PRODUCT CHANGE NOTICE

PCN#23-043

MODELS AFFECTED**ZN4PD1-63LW-S+****EXTENT OF CHANGE:**

FROM:**TO:****EFFECT OF CHANGE:**

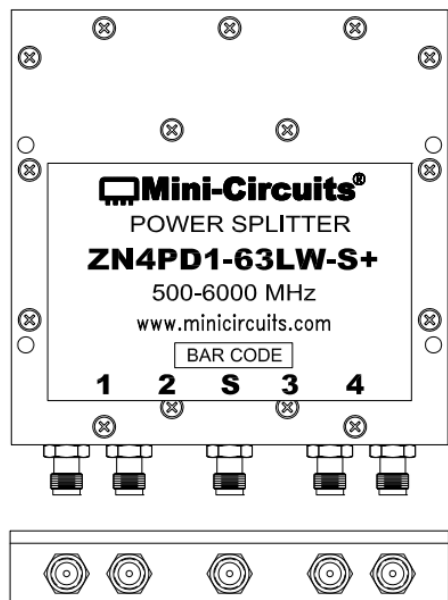
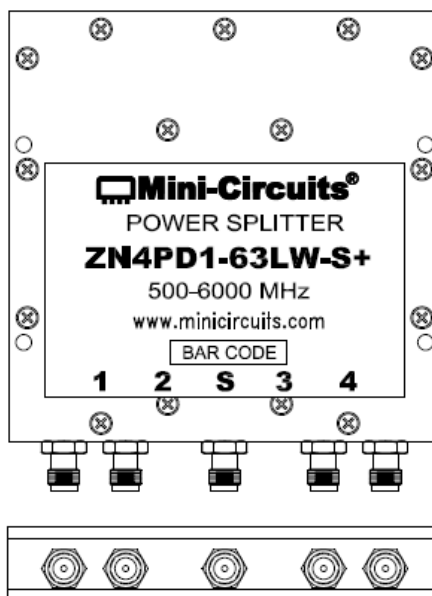
Modification of mechanical assembly by adding bottom cover and screws to case

Change to FORM (Appearance)
